WATER PRODUCTION FACILITIES ELECTRICAL UPGRADES PROJECT

Solicitation Number: CO-00523

Job No.: 21-6007

ADDENDUM No. 3

DRAWING NO.
C4

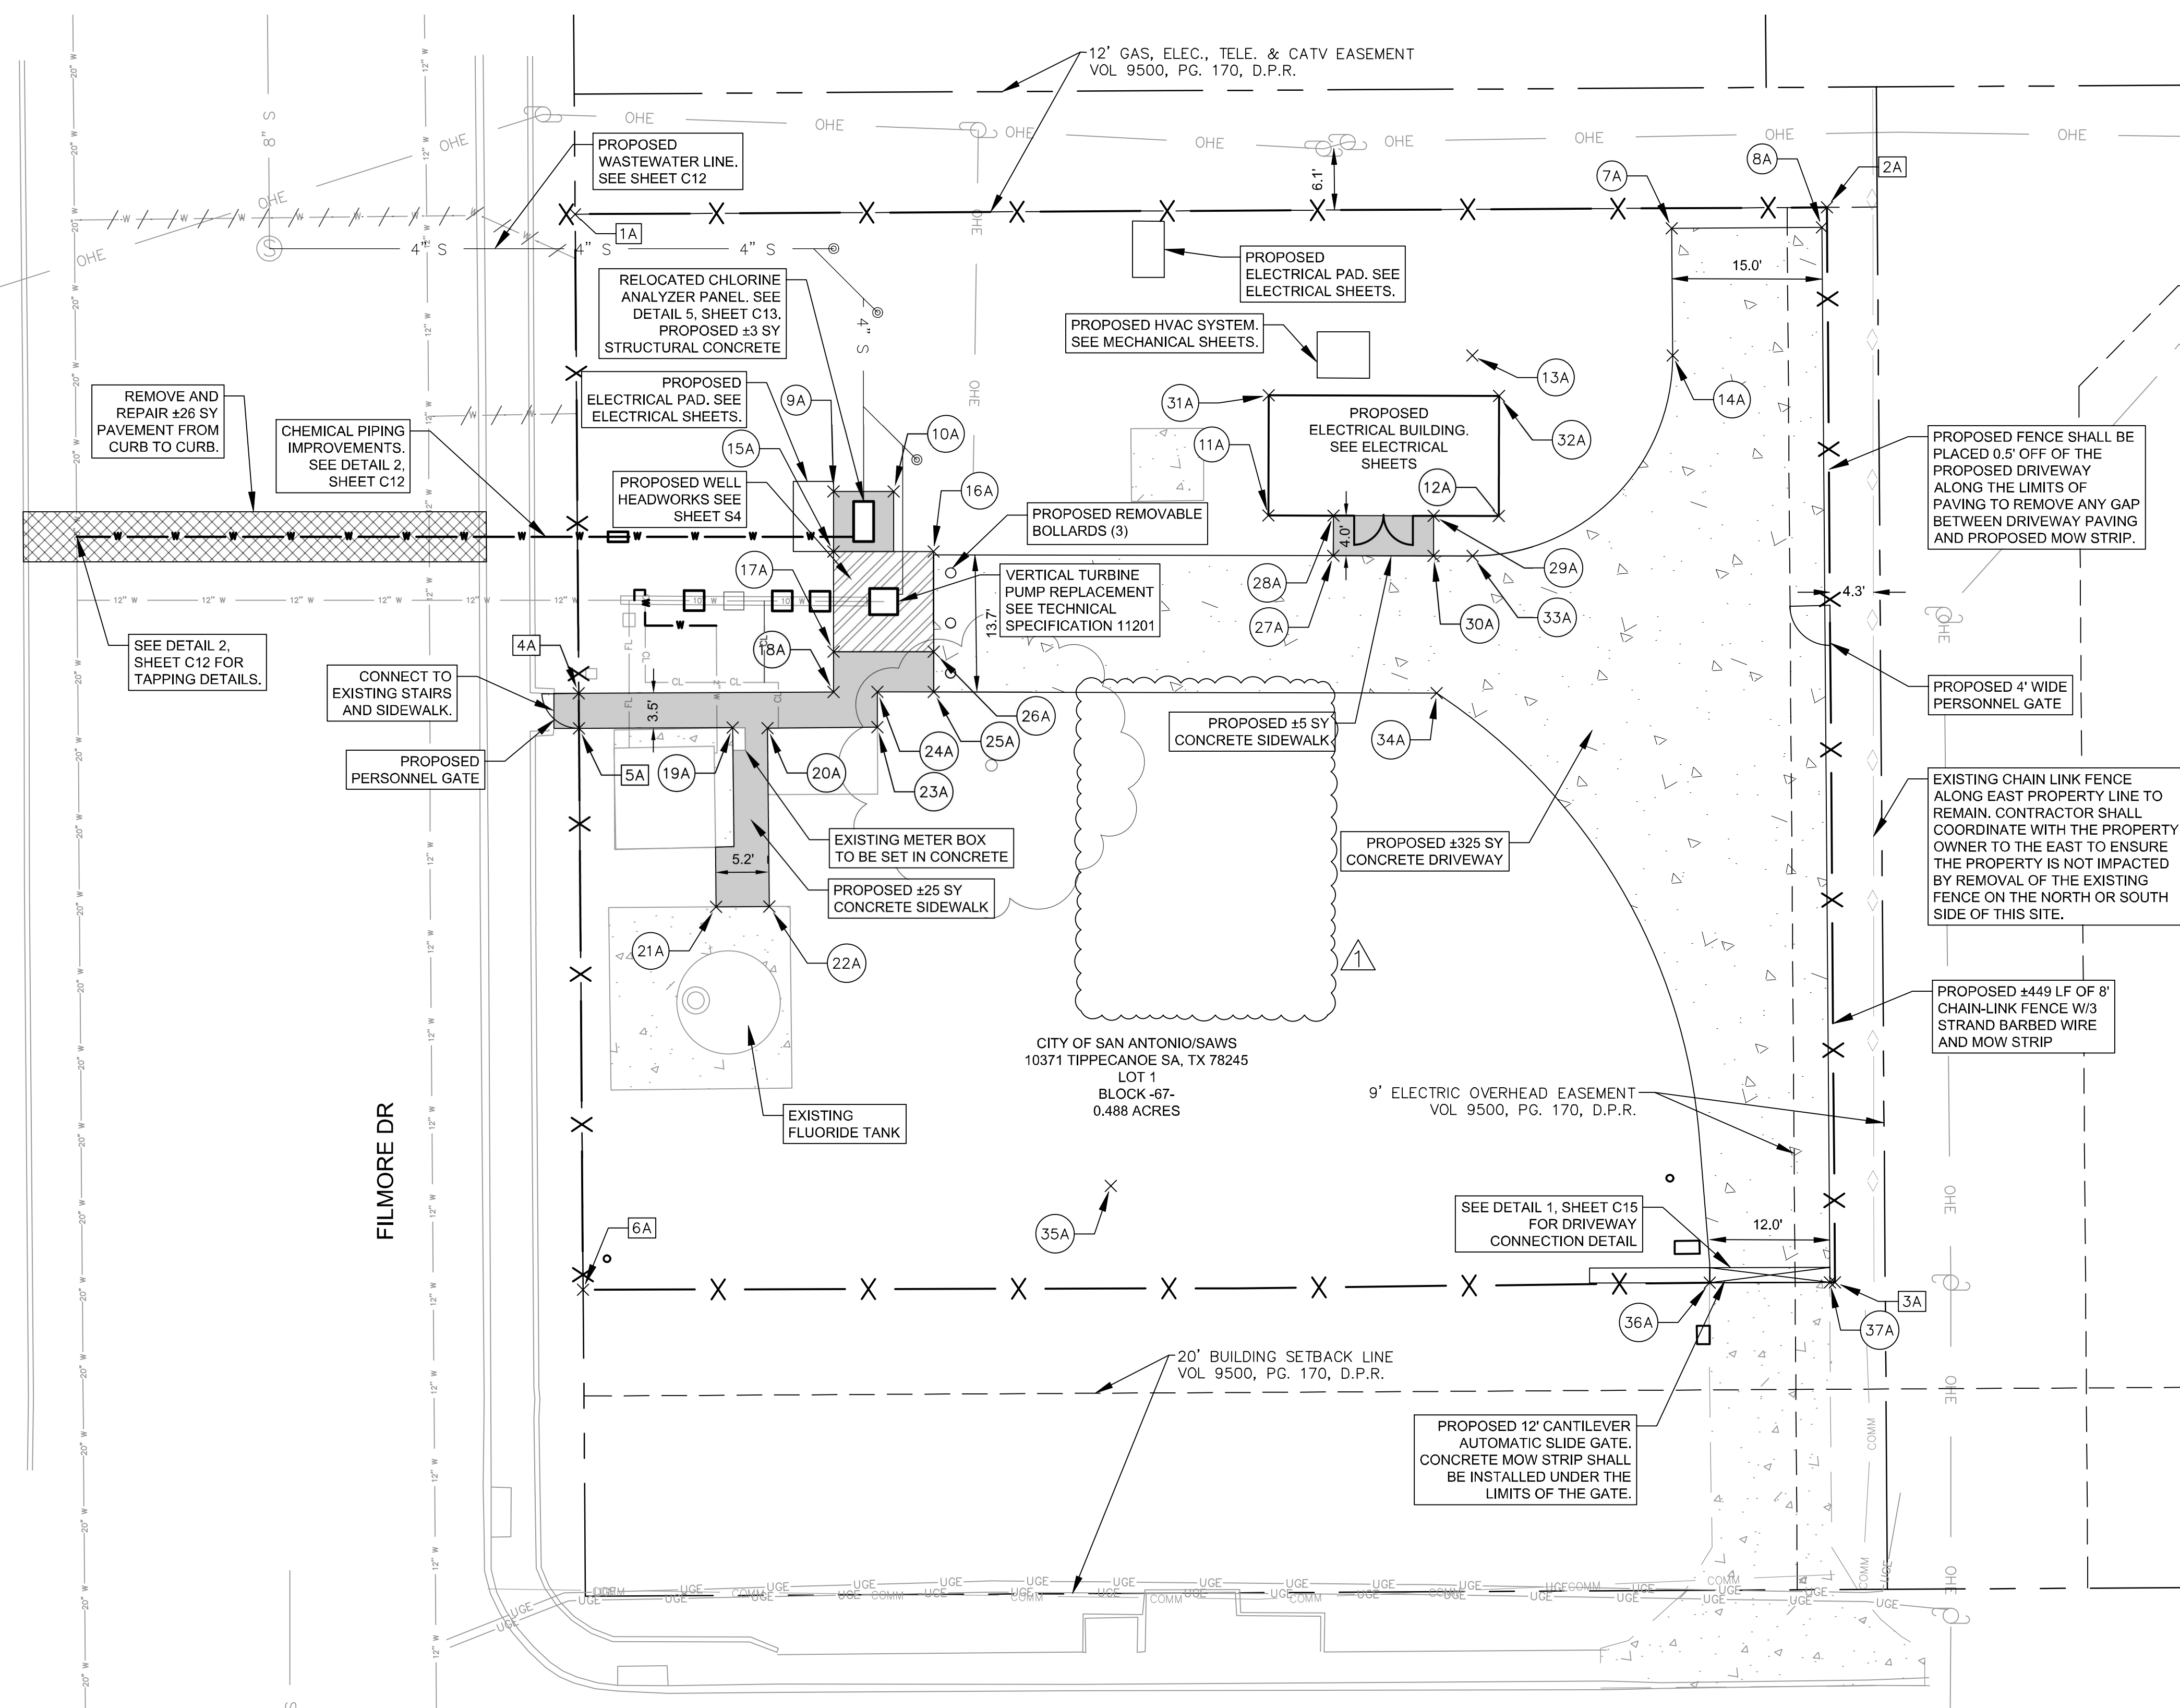
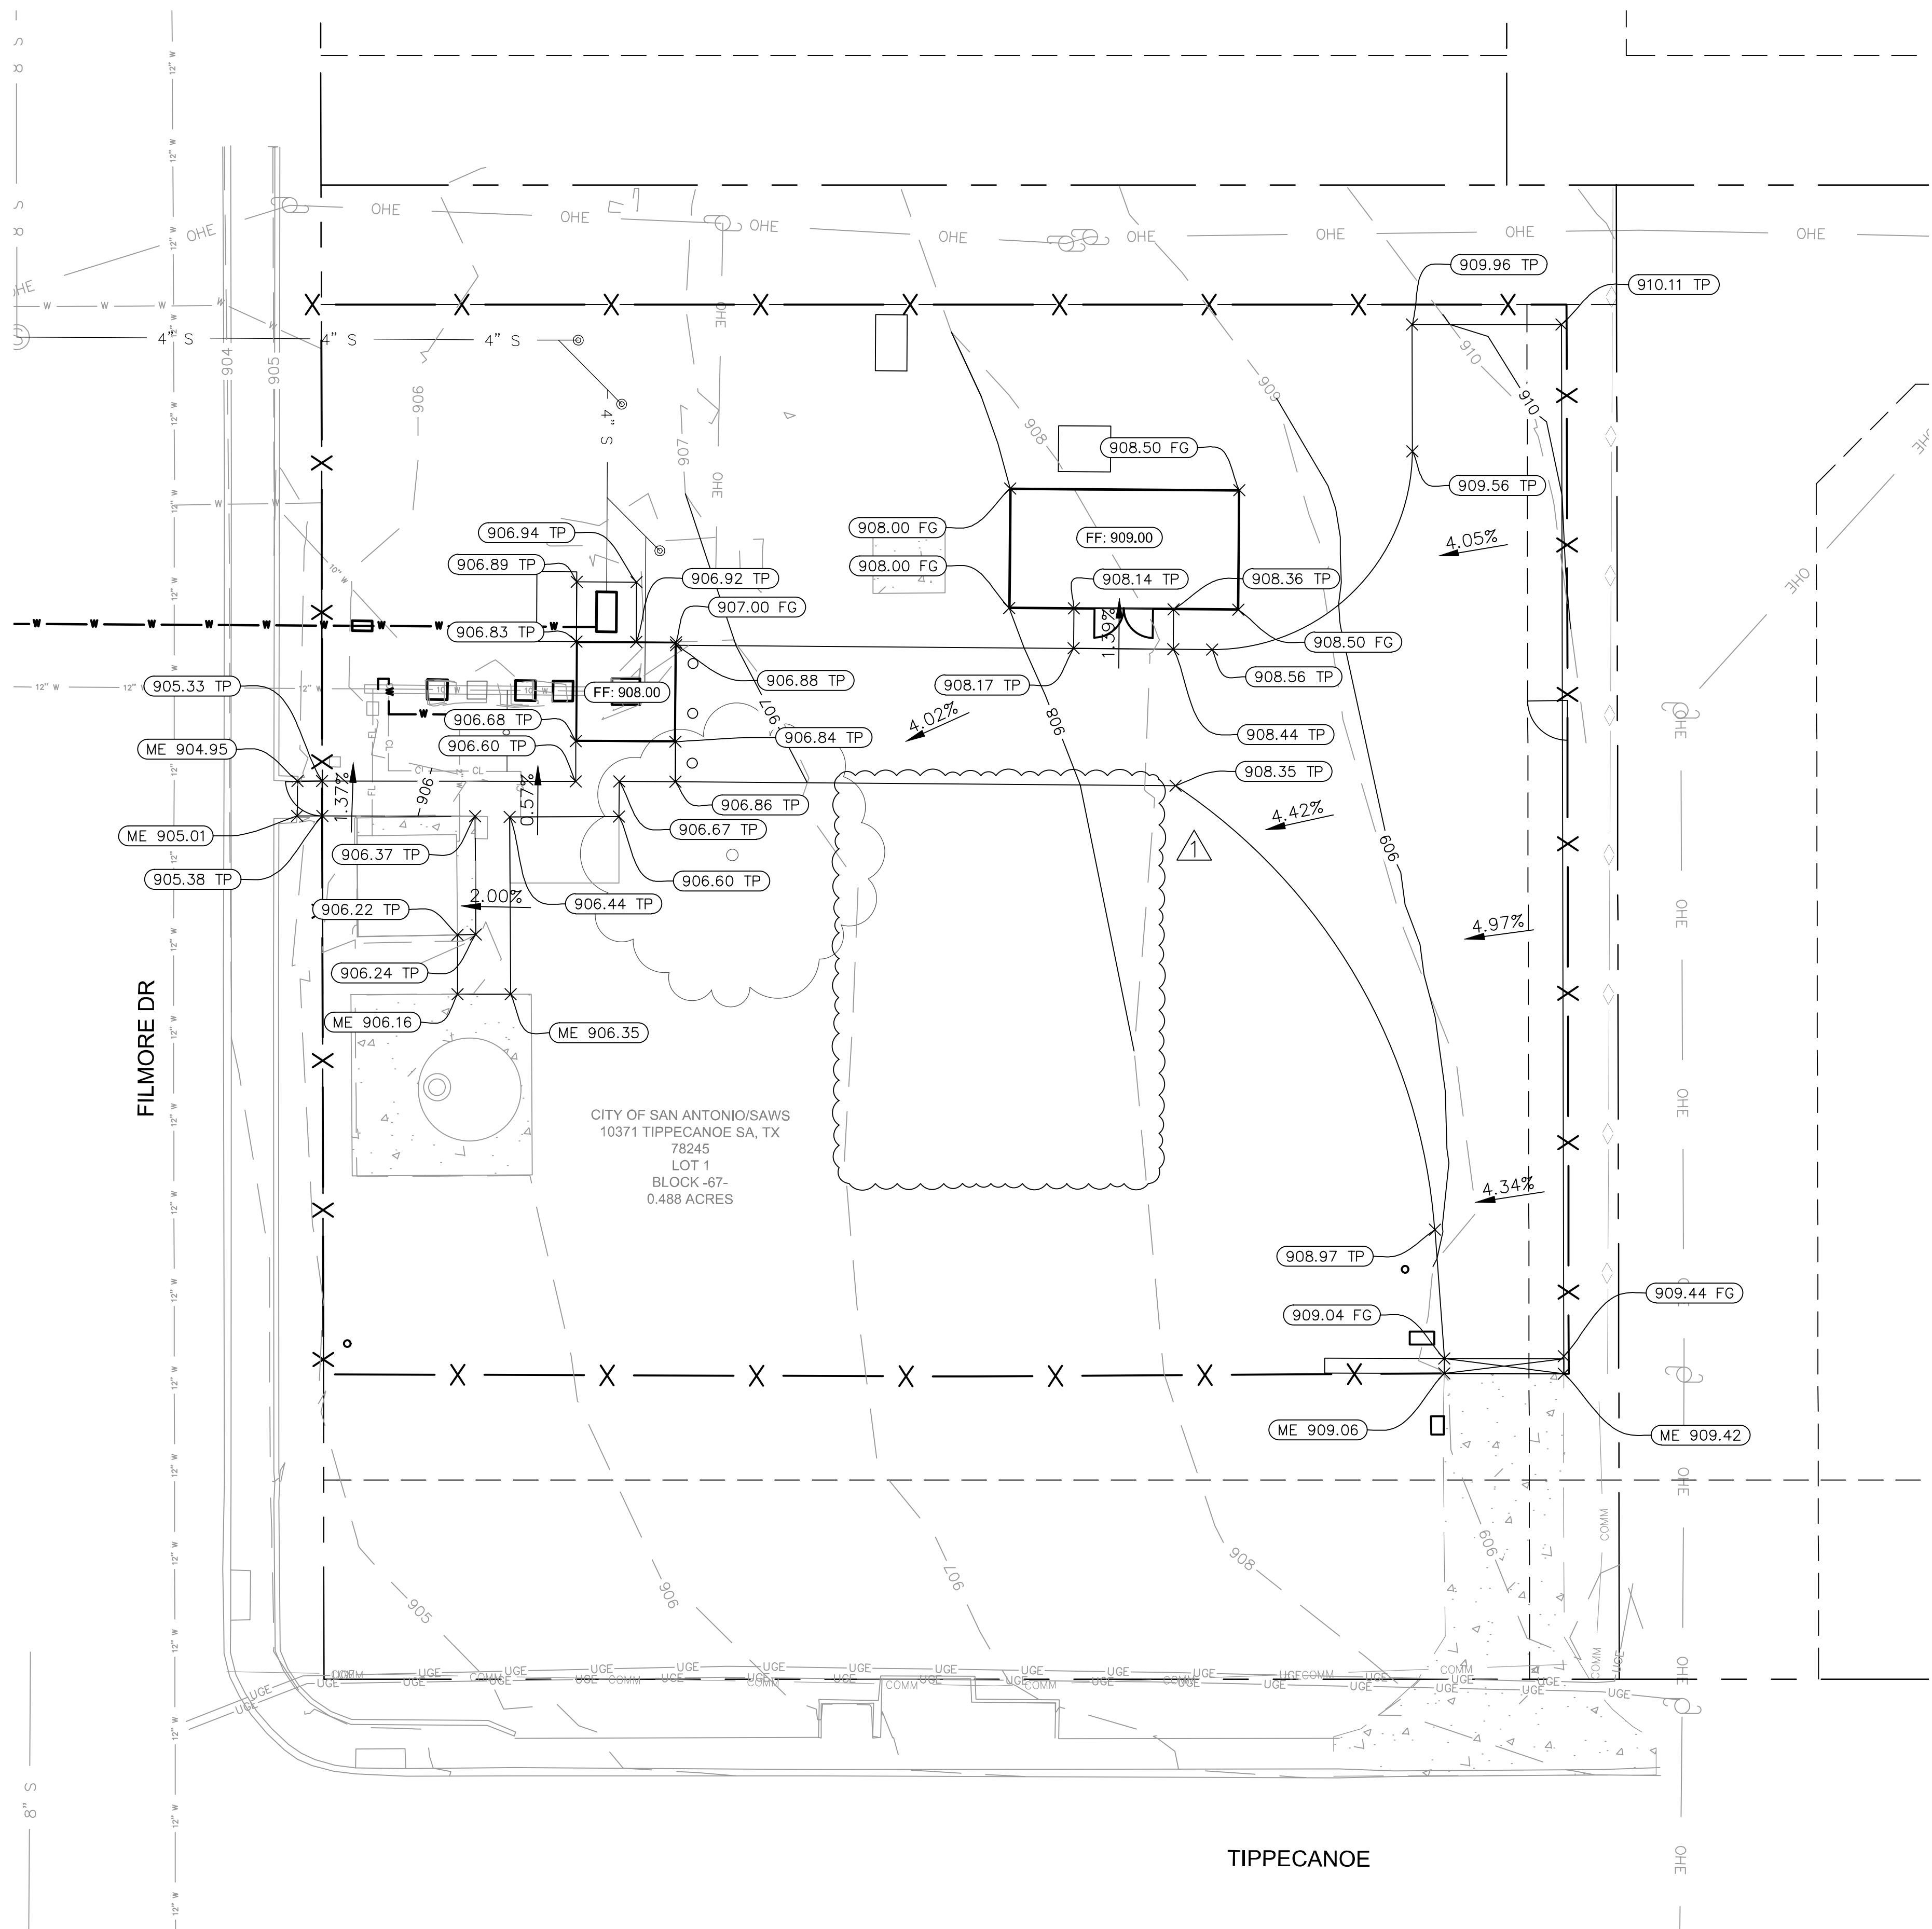
- 1. Drawing C4 – Civil Proposed Plans – Tippecanoe
 - A. REMOVE and REPLACE this sheet in its entirety with the corresponding sheet attached to this addendum.

- 7. Drawing E6 – Proposed Site Plan – Tippecanoe
 - A. REMOVE Proposed Standby Generator with Containment and associated keyed note 11.
 - B. REMOVE underground ductbank 6.
